Harnett County Department of Public Health

Construction Authorization

ISSUED TO: KB Homes Raleigh PROPERTY LOCATION: 268 Saint Clair Drive
 SUBDIVISION Birchwood Grove LOT # 88

3-Bedroom Septic Layout
 Lot 88, Birchwood Subdivision
 Harnett County, North Carolina

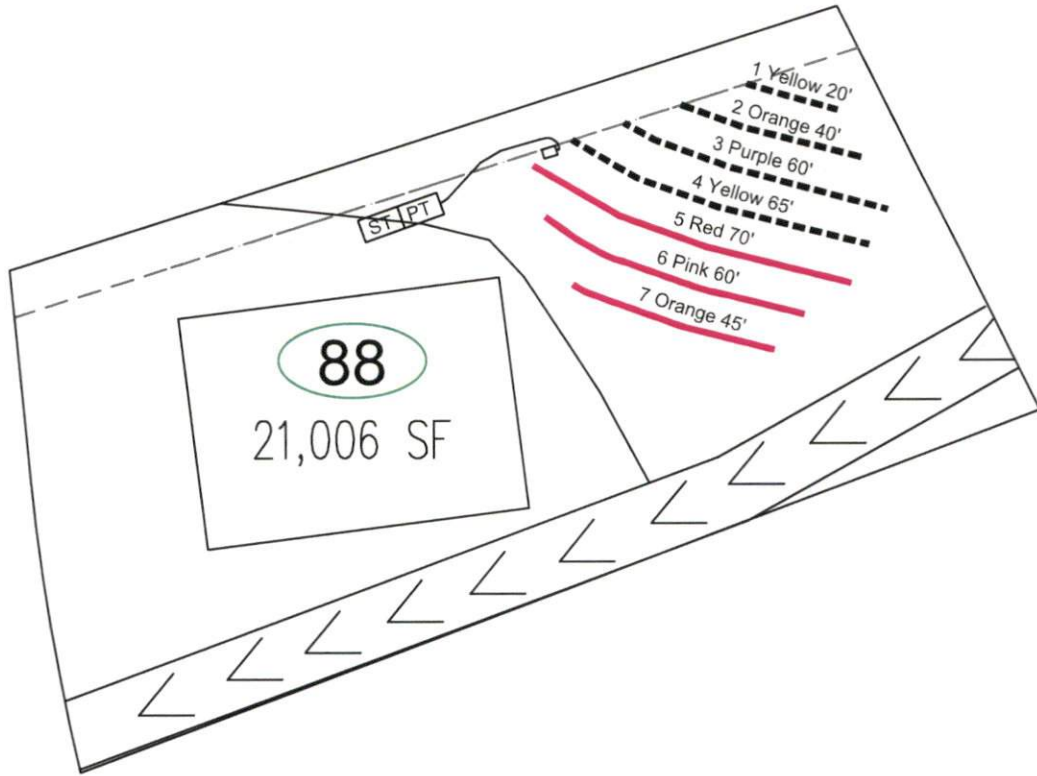
Facility Type: SFD (38'x42') New Expansion Repair
 Basement? Yes No Basement Fixtures? Yes No
 Type of Wastewater System** ~~Pump 25% Reduction System~~ T+J PANEL (Initial) Wastewater Flow: 360 GPD
 (See note below, if applicable)
~~Pump 25% Reduction System~~ (Repair) T+J PANEL

Septic Tank Size <u>1000</u> gallons	Number of trenches <u># 3</u>	Trench Spacing: <u>9</u> Feet on Center
Pump Tank Size <u>1000</u> gallons	Exact length of each trench <u>300 VARIOUS</u> feet	Soil Cover: <u>6</u> inches
	Trenches shall be installed on contour at a	(Maximum soil cover shall not exceed
	Maximum Trench Depth of: <u>18</u> inches	36" above the trench bottom)
	(Trench bottoms shall be level to +/- 1/4" in all directions)	
Pump Requirements: _____ ft. TDH vs. _____ GPM		Aggregate Depth: _____ inches below pipe
		_____ inches above pipe
Conditions: <u>CA REVISED DUE TO GRADING ON LOT</u>		_____ inches total

System: Pressure Manifold Lines: 5-7, (175') T&J Panel 50% Reduction 0.35 Soil LTAR
Repair: Pressure Manifold Lines: 1-4, (185') T&J Panel 50% Reduction 0.35 Soil LTAR
